SERVICE BULLETIN

DN-139.1*
EN-27.1*
FN-15.1*

DATE: 18 MARCH 1986
PAGE 3 OF 5

Figure 1. Cooling Fan Assembly Pulley Inspection/Rework

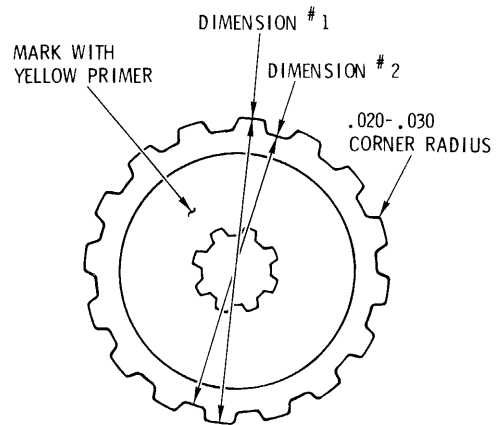
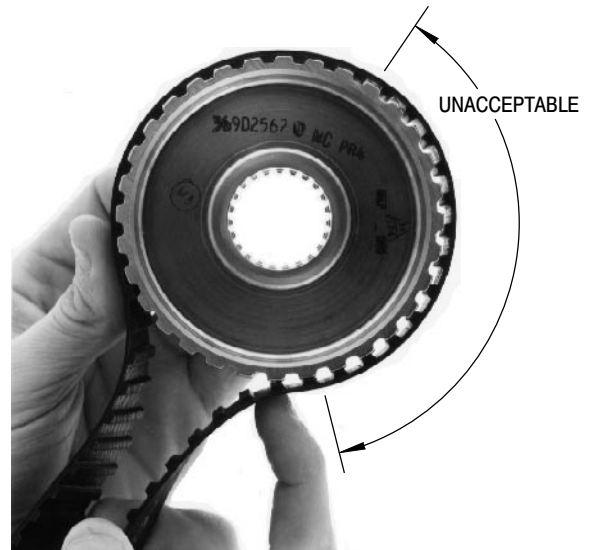
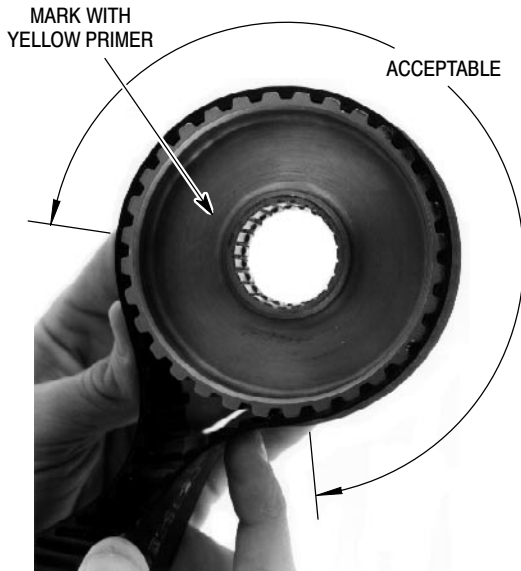
- A. Disassemble cooling blower assembly as required to gain access to pulley drive assemblies per Section 9 of applicable HMI Vol. I. Remove pulley assemblies.
- B. Using a new fan belt, perform inspection of pulleys by loosely wrapping drive belt around the pulley assemblies as shown in Figure 1.
- C. Figure 1 depicts acceptable and unacceptable meshing between the drive belt and pulley assemblies. Those smaller pulleys which are found to be acceptable shall be further inspected for having too sharp of teeth edges. The teeth on the smaller pulleys shall have edges which feel smooth when touched.
- D. All pulleys found to be UNACCEPTABLE shall be returned to an approved MDHC Service Center or Distributor for replacement.
- E. Those small pulleys found to mesh properly with the fan belt and yet have unacceptable teeth edges shall be further inspected and reworked per the following steps:

- 1) Measure O.D. of pulley from the tops of the pulley teeth as shown in figure 1.
Dimension #1 = _____ .
- 2) Measure O.D. from the bottoms of the pulley teeth grooves as shown in figure 1.
Dimension #2 = _____ .
- 3) Subtract "Dimension 2" from "Dimension 1".
Dimension #3 = _____ .
- 4) Divide "Dimension 3" by 2.
Dimension #4 = #3 / 2 = _____ .

Note - Dimension #4 shall not be less than 0.078; If Dimension #4 is less than 0.078, return pulley to an Approved MDHC Service Center or Distributor for a replacement part. If Dimension #4 is 0.078 or greater, rework pulley per the following steps:

- a) Mark retaining ring for proper placement during reinstallation.
- b) Adequately support retaining ring and carefully press pulley out of ring.
- c) Using abrasive paper, smooth edges of the teeth to obtain a corner radius of 0.020 to 0.030.

- d) Smooth old stake point on pulley (4 places).
- e) With same side facing pulley teeth, reinstall retaining ring and stake at four places half way in between old stake points.
- f) Using yellow primer paint, mark pulley as shown in Figure 1.
- F. Those larger pulleys found to mesh properly with fan belt shall be marked using yellow primer paint as shown in Figure 1.
- G. Using a new fan belt and acceptable pulley assemblies, reassemble cooling blower assembly per Section 9 of applicable HMI Vol. I except as noted below.
